**ORDINANCE NO. 5089**

**AN ORDINANCE APPROVING A LANDSCAPE PLAN AND STREET TREE PLAN FOR THE BAKER CREEK NORTH SUBDIVISION**

**DECISION, CONDITIONS, FINDINGS OF FACT AND CONCLUSIONARY FINDINGS FOR THE APPROVAL OF A LANDSCAPE PLAN AND STREET TREE PLAN FOR THE BAKER CREEK NORTH SUBDIVISION**

**DOCKET:** L 12-19 (Tree Removal, Landscape Plan and Street Tree Plan)

Figure 4. Proposed Street Tree Plan

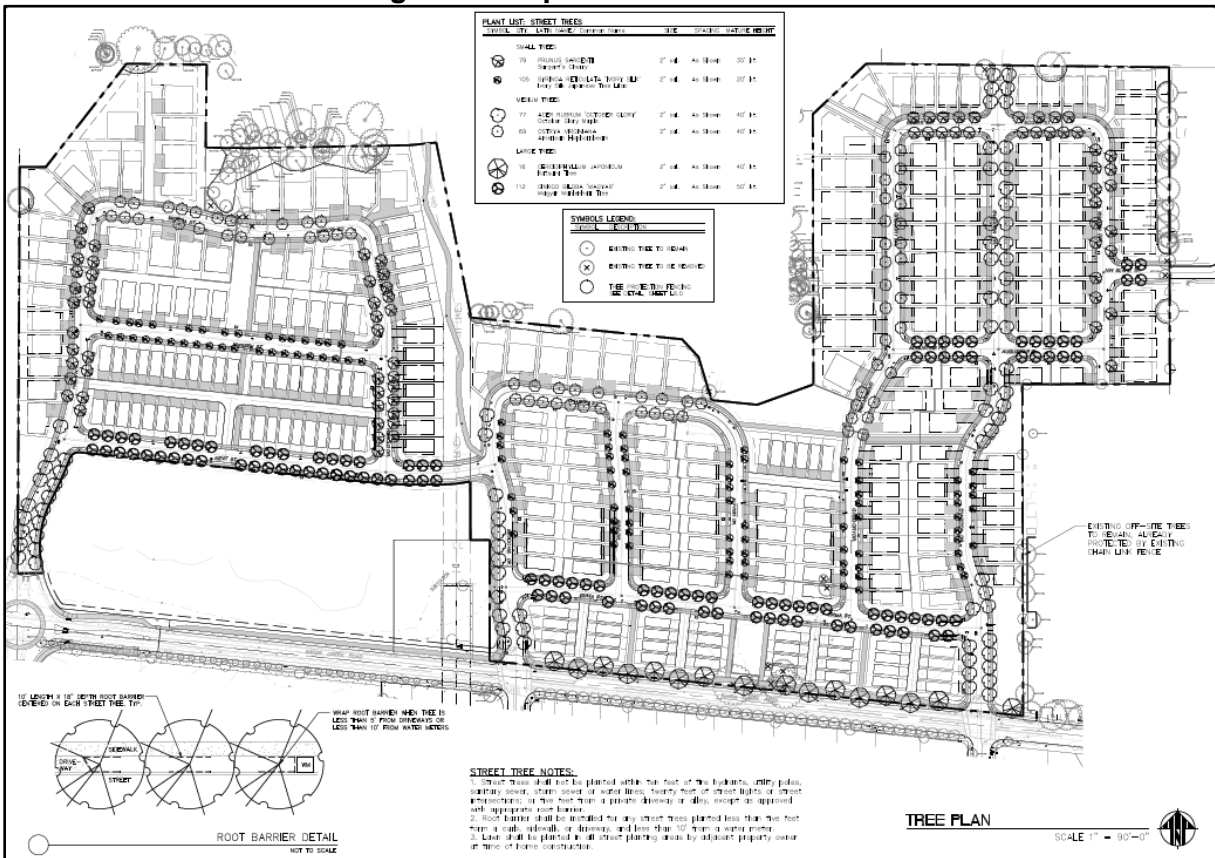
- Recognizing that street tree plans are reviewed and approved at a later date by the Planning Department and the Landscape Review Committee, we did note that several of the proposed tree locations will need to be adjusted due to probable conflicts with utilities and due to street sight distance concerns.

**FINDING: SATISFIED.** The City concurs with the applicant's finding's finding. Drawing L1.0 Street Tree Plan indicates that 17 trees are proposed for removal. The applicant has indicated the location, type, and size of the trees requested for removal on the Street Tree Plan, shown in more detail in Street Tree Plan Enlargements A-F and accompanying tree schedules below. The requested tree removals are not designated as exempt by the zoning ordinance, therefore the requested removals require City approval.

5. That only the 17 existing trees identified for removal on Drawing L1.0 Street Tree Plan shall be approved for removal.
6. That landscaping be provided for Sewage Pump Station Tract 'G'. Landscaping shall be provided at an amount equal to or greater than 25 percent of the gross area of the tract, and shall provide screening of the pump station structure from surrounding properties.

- iv. *Ostrya virginiana* (American Hophornbeam)
    - v. *Prunus sargentii* (Sargent Cherry)
15. That street trees in addition to those shown on the Street Tree Plan dated 11/18/2019 shall be provided in the following locations, unless a utility is present that creates a setback requirement:

**CONDITION FOR FINDING:** That only the 17 trees identified for removal on Drawing L1.0 Street Tree Plan shall be approved for removal.

Pump Station 'Tract G':

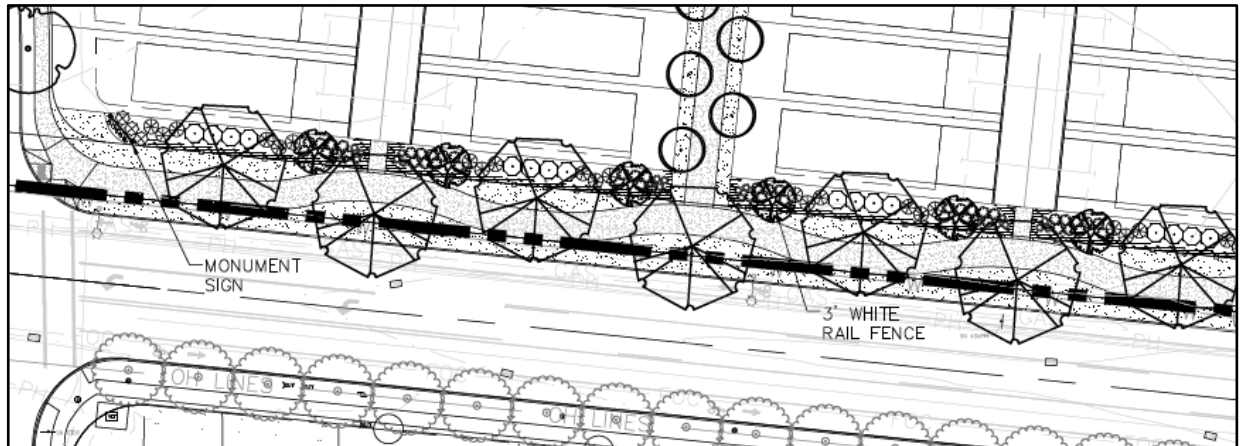
Landscaping has been proposed in excess of the 25 percent minimum for each common tract in the planned development, except for Tract G, the sewage pump station tract. Therefore, a condition is included requiring a minimum 25 percent of the gross area of Tract G be provided with landscaping.

Landscaping was not proposed for Tract G at the intersection of Charles Street and Alfred Drive, where a sewer pump station is located. Tract G is adjacent to residential lots 60, 109, and 110, and is across the street from lots 49, 111, and Open Space Tract F. There is no screening or buffering of the pump station from the adjacent residential uses. A condition of approval requiring landscaping to screen and buffer the sewage pump station has been included.

**CONDITION FOR FINDING:** That landscaping be provided for Sewage Pump Station Tract ‘G’. Landscaping shall be provided at an amount equal to or greater than 25 percent of the gross area of the tract, and shall provide screening of the pump station from surrounding properties.

Open Space 'Tract I':

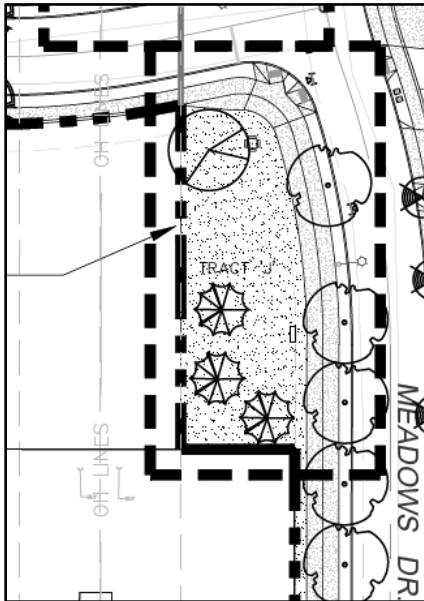
Based on comments from McMinnville Water & Light, trees surrounding the electric substation should be limited in height to 25 feet. A condition is included limiting the height of any trees located in Open Space Tract I to a maximum mature canopy height of 25 feet.

Open Space 'Tract J':

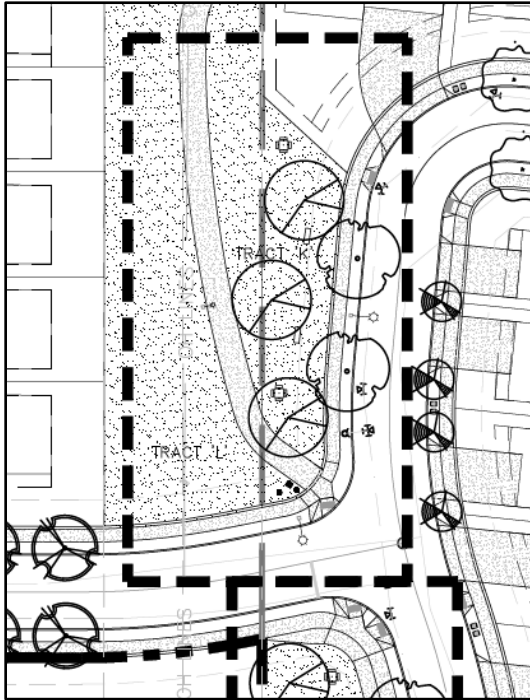
Douglas Fir trees can grow to approximately 100 feet tall and 30 feet wide, and Sunburst Honey Locust grow to approximately 40 feet tall and wide. Based on comments from McMinnville Water & Light, trees surrounding the electric substation should be limited in height to 25 feet. Additionally, trees adjacent to the transmission easement should be limited in height 40 feet and located such that no canopy encroaches into the transmission easement. A condition is included limiting the height of any trees in Open Space Tract J adjacent to the electric substation to a maximum mature canopy height of 25 feet, and no tree in Tract J shall

exceed a maximum mature canopy height of 40 feet or be located such that no canopy encroaches into the transmission easement.

Open Space 'Tract K':

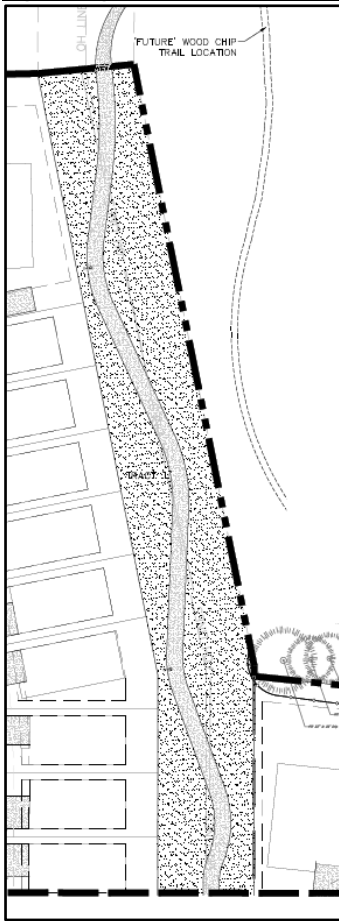
Sunburst Honey Locusts grow approximately 40 feet tall and wide. Based on comments from McMinnville Water & Light, trees in Tract K should be located such that no canopy encroaches into the transmission easement. A condition is included limiting the height of any trees in Open Space Tract K to a maximum mature canopy height of 40 feet and to locations such that no canopy encroaches into the transmission easement.

Open Space & Access Easement 'Tract L':

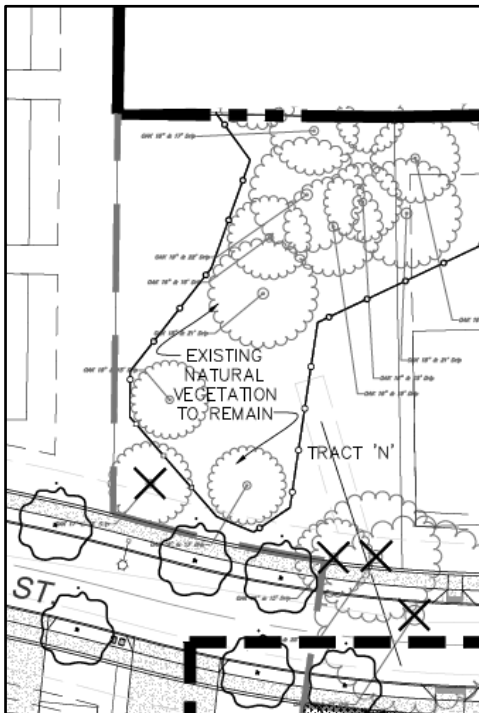
Additionally, no street trees should be located within the public right-of-way in the transmission line easement, where they would be in incompatible with electrical transmission lines overhead.
